15/00619/FUL- South West Milton Keynes

Proof of Evidence - Highways /
Transportation (CD12/M)

Date: 13 April 2021

Doc ref: 16414-HYD-XX-XX-RP-TP-0003

Figure 5.1: Proposed A421 left-in access (Taken from MJP Proof⁴⁸)

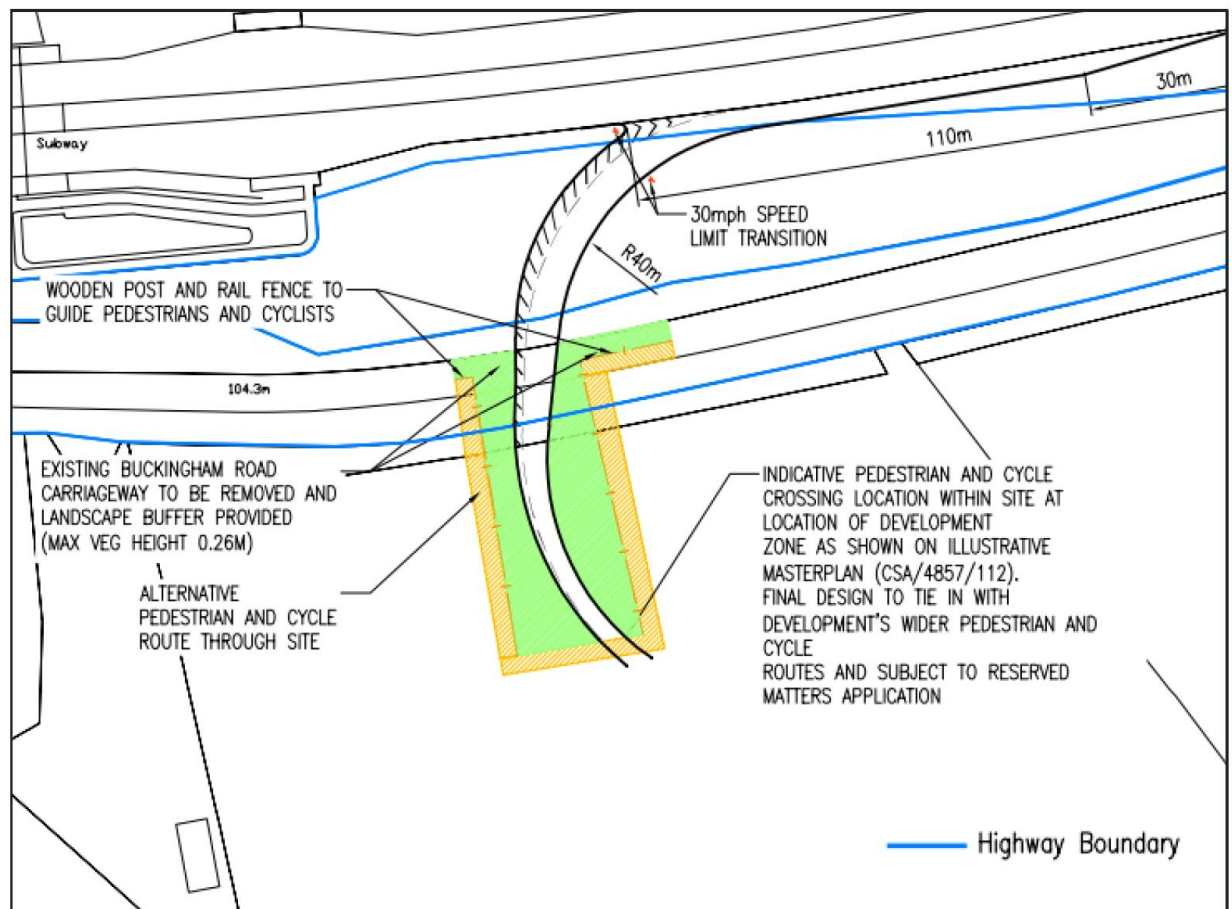
- 5.2.4 I have raised these concerns with WSP, including my further concern that the proposed pedestrian/cycle route shown in Figure 5.1 takes users off of their desire line and, in practice, pedestrians in particular would be likely to cross the proposed post and rail fence and walk across the new access on the alignment of the existing route (without proper crossing provision or visibility splays)⁴⁹.

- 5.2.6 Consequently, I am of the view that this access arrangement lacks detail in its design; is out of step with the relevant design guidance; would increase the weaving of vehicles between Tattenhoe Roundabout and the access; would likely lead to deceleration on the A421 mainline by vehicles entering the site, as a consequence of its geometry; and does not make suitable provision for pedestrians and cyclists.

- 5.2.7 In our discussions, WSP has agreed to review the cycle provision at and around this access in light of the current design guidance set out in LTN 1/20⁵⁰. At present, the access design in WSP's evidence to the Inquiry does not comply with current design guidance and, on that basis, is under review by the appellant in relation to the live planning application for the wider development.

Figure 6.1: Roundabout exits blocked by HGVs

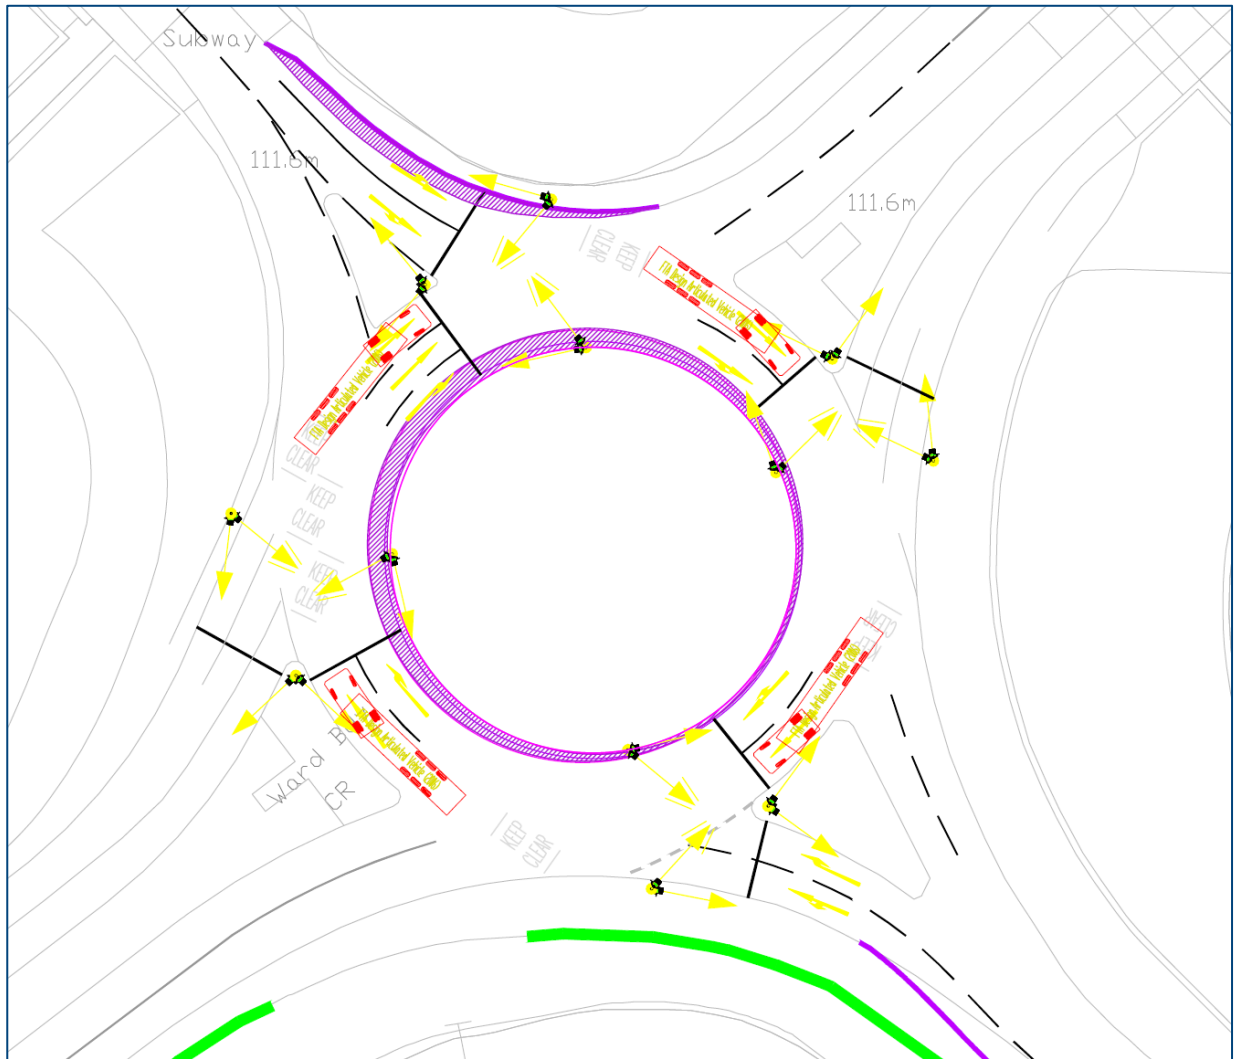
- 6.3.12 Similarly, an articulated HGV stopped at the lights would completely or partially block the exits of the roundabout as shown below:

6.3.13 Furthermore, Keep Clear markings have been proposed to mitigate against this potential blocking back. Given that the junction is signalised and would be congested at busy periods, it is unlikely that these markings would be observed by drivers and they are not enforceable.

Figure 6.2: Forward visibility onto pedestrian crossing

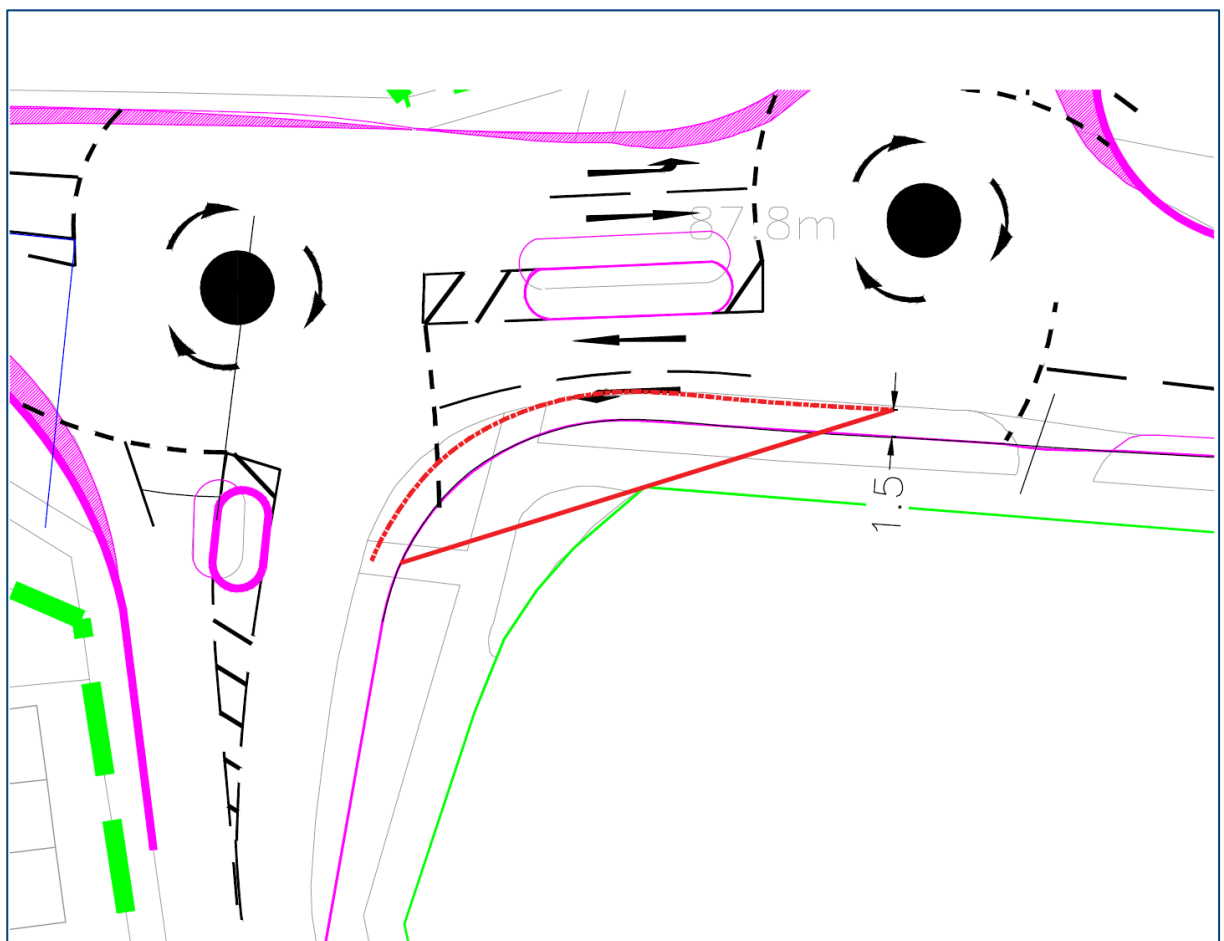
- 6.4.17 Under the proposals, the approach from Newton Road (southern arm) aims drivers in the right-hand lane directly at the central island. This could make manoeuvring around the island difficult.
- 6.4.18 The forward visibility to pedestrians waiting to cross on the eastern side of Newton Road is worsened by the proposals. Taking an MfS SSD (given the speeds and environment), there is currently space to accommodate an approximately 41.9m SSD to the centre of the footway at the crossing. Under the proposals this is reduced to approximately 31.9m (both distances measured along the driver's path), as shown Figure 6.2:

Figure 6.4: Proposed Tattenhoe Roundabout improvement scheme (9442-TP-SK-004 P05)

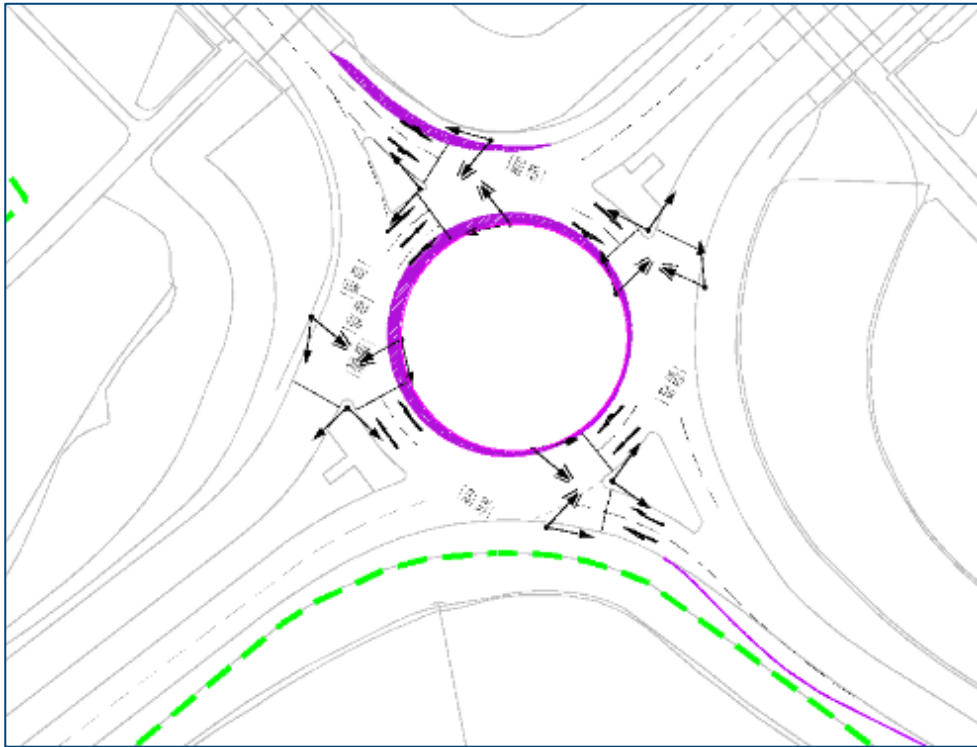
- 6.4.32 The RSA⁷⁸ notes the potential requirement to relocate street furniture around the junction in order to accommodate carriageway widening (Problem 3, page 8). This should be confirmed at planning stage, particularly given the level differences and potential requirement for earthworks to accommodate any significant re-siting.

- 6.4.33 Additional detail is also required on the Buckingham Road approach, as the proposed widening does not illustrate how the carriageway centreline would be accommodated and over what length the approach lanes would develop. An Advance Direction Sign for the roundabout is presently sited within the area indicated for carriageway widening and, given the importance of its location relative to the nearby junctions, the location for its re-provision needs to be confirmed.

- 6.4.34 The proposed mitigation works lie, in part, beyond the planning application red line boundary, as indicated below:

6.4.35 In summary, the modelled operation of the junction is not accepted, as queuing around the roundabout would likely lead to exit blocking. Furthermore, the design needs to be worked-up in additional detail as

Figure 6.6: Proposed junction mitigation scheme, including works to layby to west of roundabout (70069442-004 P05)

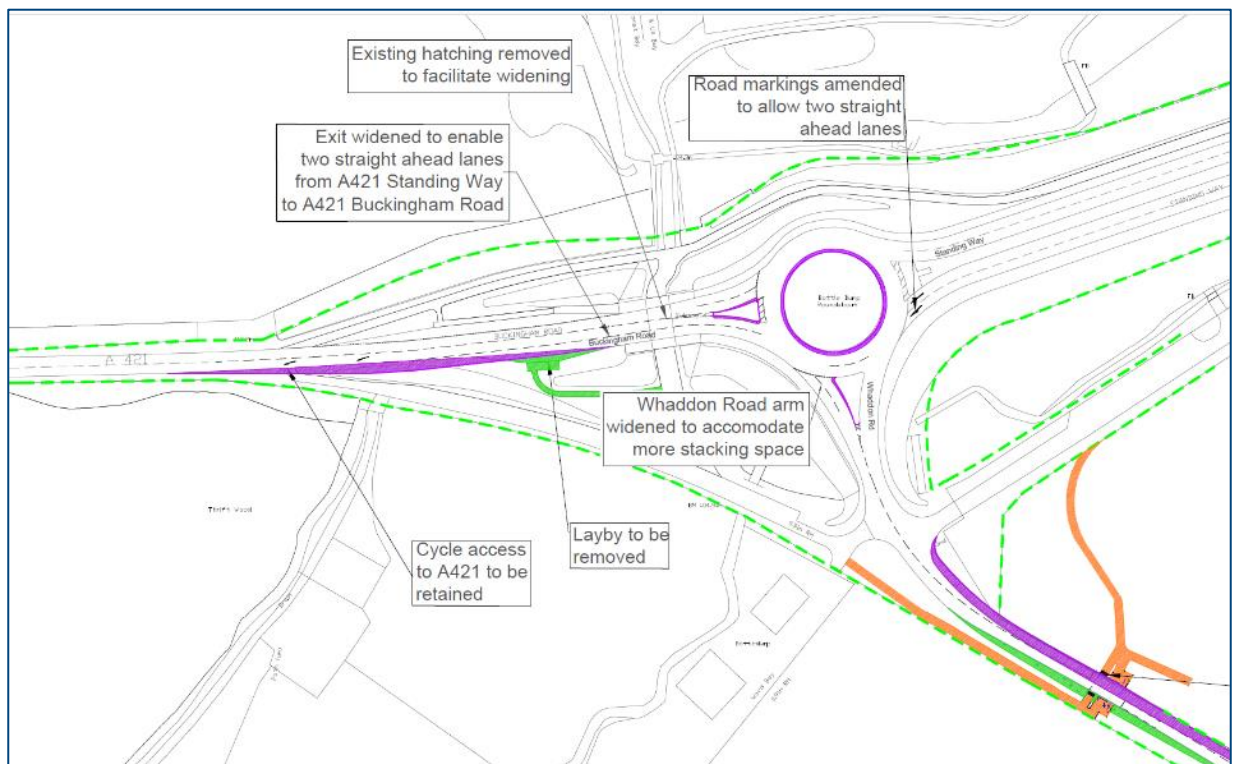
6.4.46 RSA⁸² (problem 11) highlights the lack of visibility of the new Pegasus crossing for vehicles traveling from the roundabout down Whaddon Road. The Designers state that the vegetation will be cut back and maintenance of this visibility will be the responsibility of Buckinghamshire Council. However, it seems from the design drawing that the visibility splay (as well as some of the widening) is outside of the highway boundary. There is no mention in the Designer’s Response of any plans for this area to become Adopted. This should be clarified as it relates to the deliverability of the scheme.

6.4.47 Whilst the matter relates to the BC network, I note that some of the works proposed to the west of the roundabout do not lie within the planning red line.

6.4.48 In summary, the junction modelling is not accepted, as there would actually be significantly less capacity - and, hence, more queuing and delay, than predicted in TRN3⁸³. The proposed mitigation drawings should take account of the existing operation of the junction, including verge overrunning, and should be updated to avoid the conflicts between vehicles that are currently shown on the tracking plans.

Figure 6.9: Junction 16 - Predicted extent of AM peak queuing

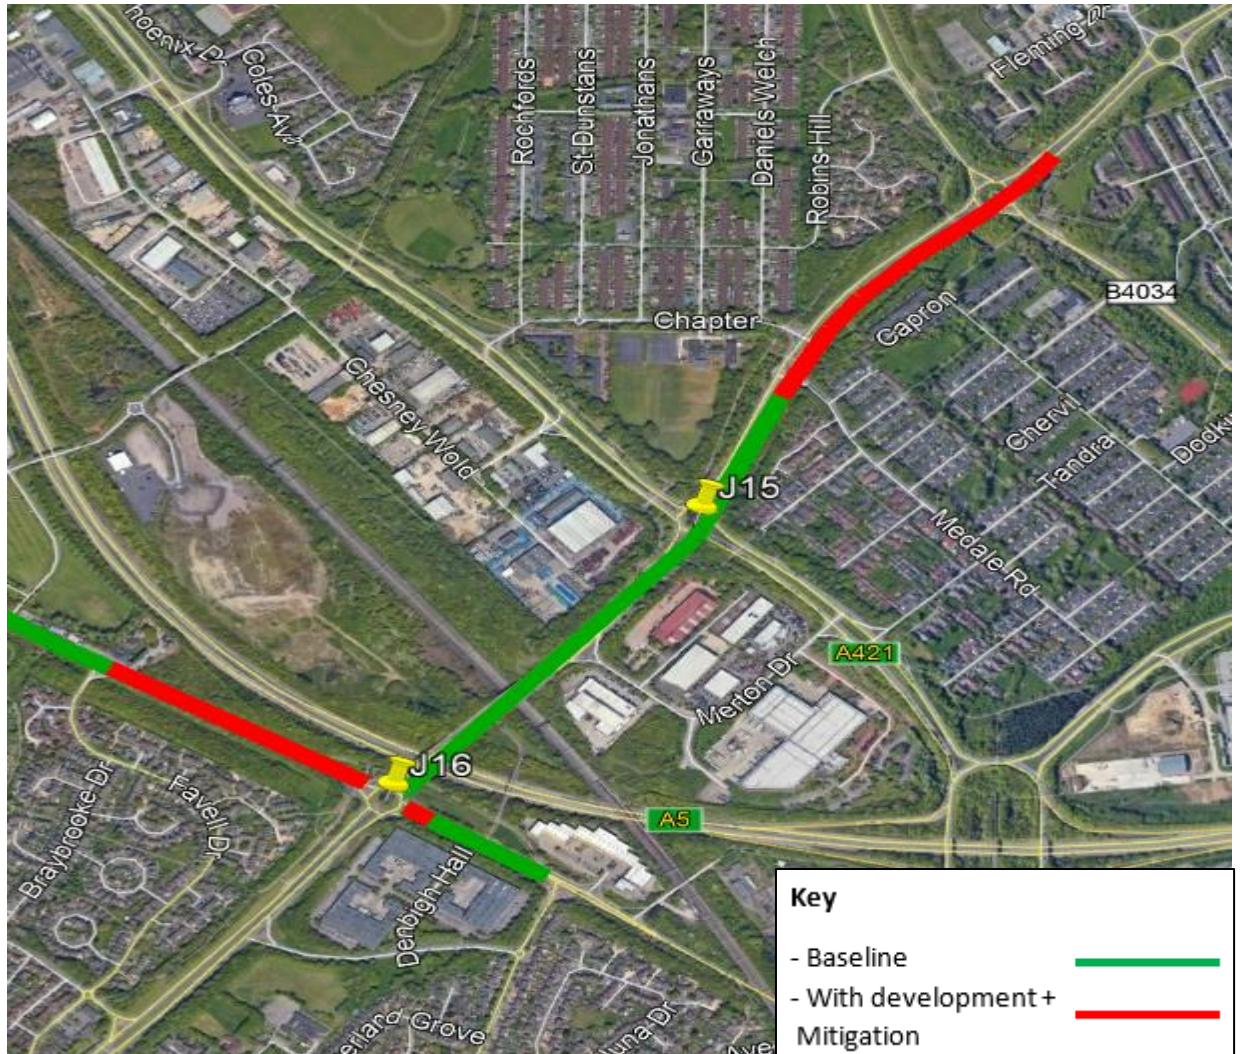
- 6.4.69 The with-mitigation development scenario indicates significant increases in queuing on the A421 (S) entry arm in the AM peak, and on the A421 (N) arm in the PM peak.
- 6.4.70 In the AM peak, development traffic would add to pre-existing queuing on the A421(N) approach which blocks back through the upstream Bleak Hall Roundabout, meaning that this queue would reach the (un-modelled) Coffee Hall roundabout.

Figure 6.10: Junction 16 Predicted extent of PM peak queuing

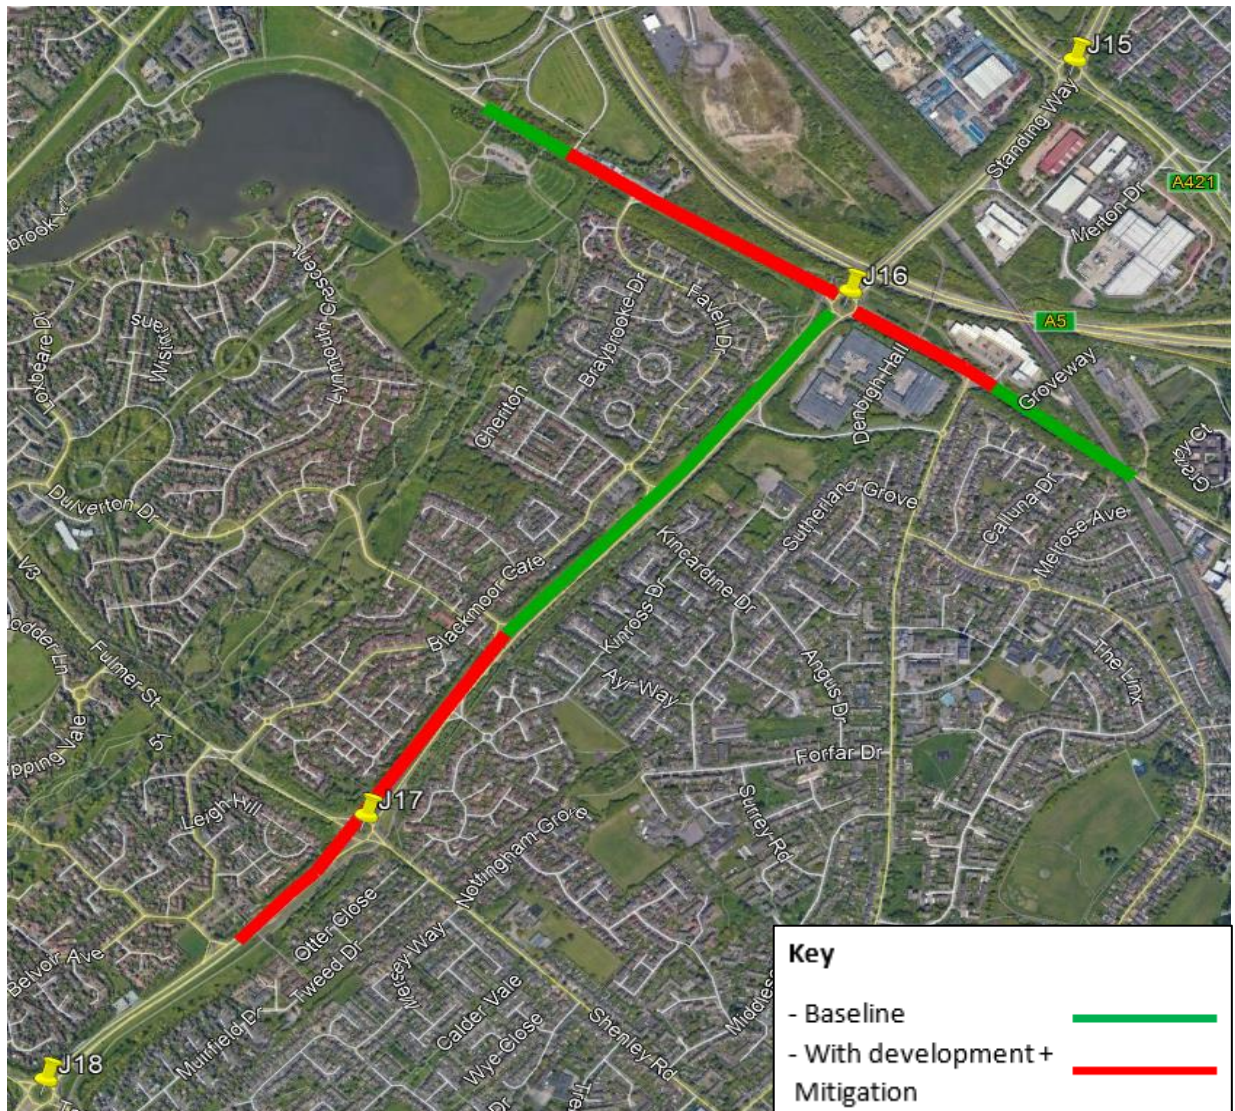
- 6.4.71 As indicated in the subsequent section, the A421(S) exit would be blocked by queued traffic from Emerson Roundabout, which is not reflected in the WSP modelling. Likewise, increased queuing from Elfield Park roundabout would cause blocking-back through Emerson Roundabout.

- 6.4.72 As with other junction mitigation proposals, no lane or guide markings are shown within the drawing. Neither is vehicle tracking included within TRN3⁹⁵.
- 6.4.73 The proposed circulatory carriageway is narrower than the maximum entry widths (not the 1.0-1.2 times recommended by DMRB).
- 6.4.74 The Watling Street (SE arm) exit has some road markings which are not tangential to the traffic island and should be corrected.
- 6.4.75 On all arms the entry path is made flatter and therefore vehicle speeds made faster by the proposals.
- 6.4.76 In summary, the scheme results in a worsening of conditions for pedestrians and queuing which interacts with other junctions in the vicinity. The scheme drawings lack the required level of detail and assessment for planning stage.

Figure 6.11: Junction 17 - Predicted extent of PM peak queuing

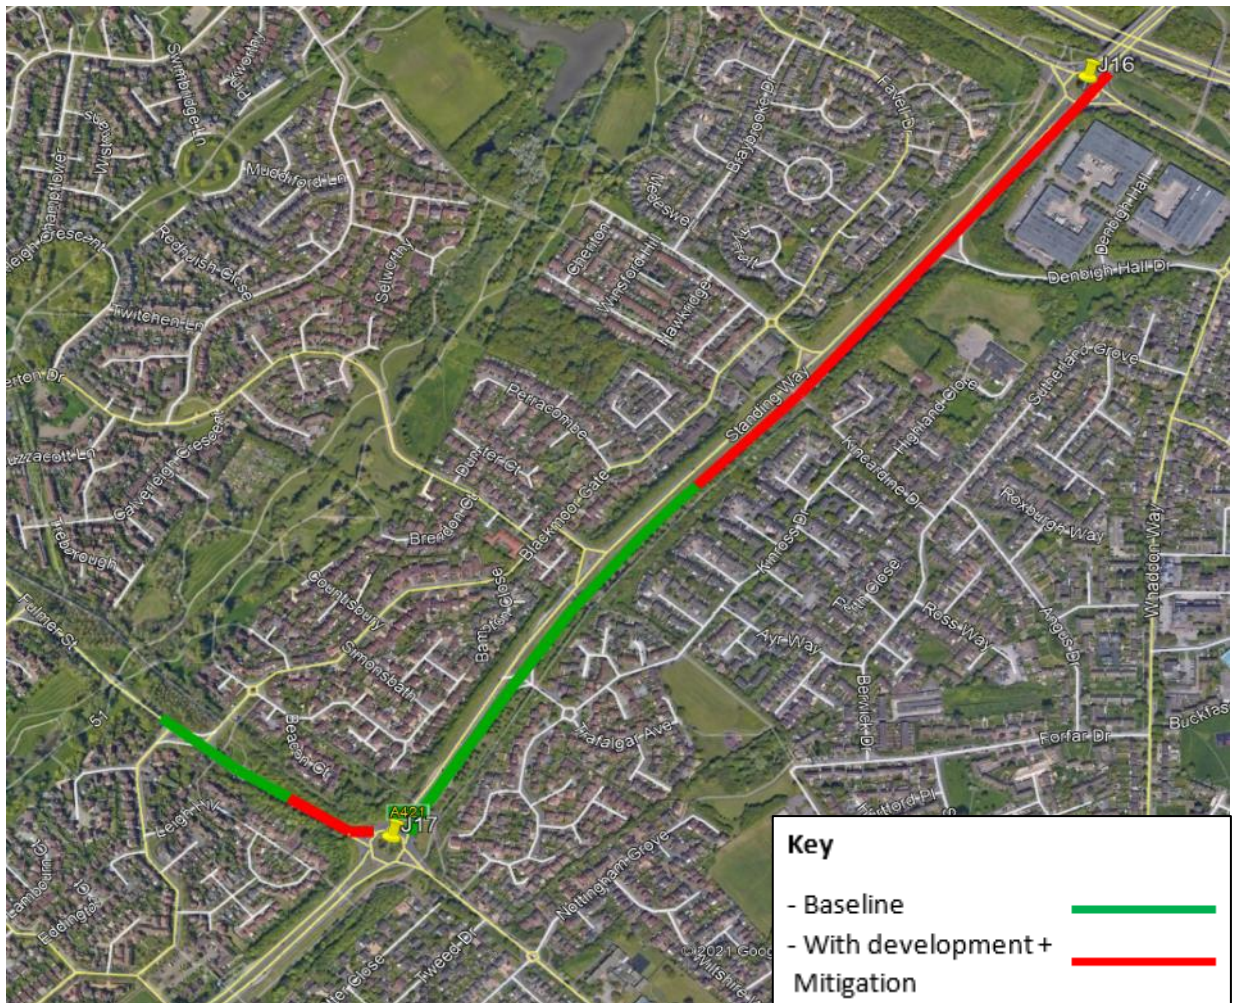
6.4.88 The proposed mitigation would appear to be outside of design standards, requires re-siting of street furniture / VRS, and has a potentially significant adverse impact on trees. The operation of the junction is predicted to create, and be impacted by, queuing at other junctions on the surrounding network.
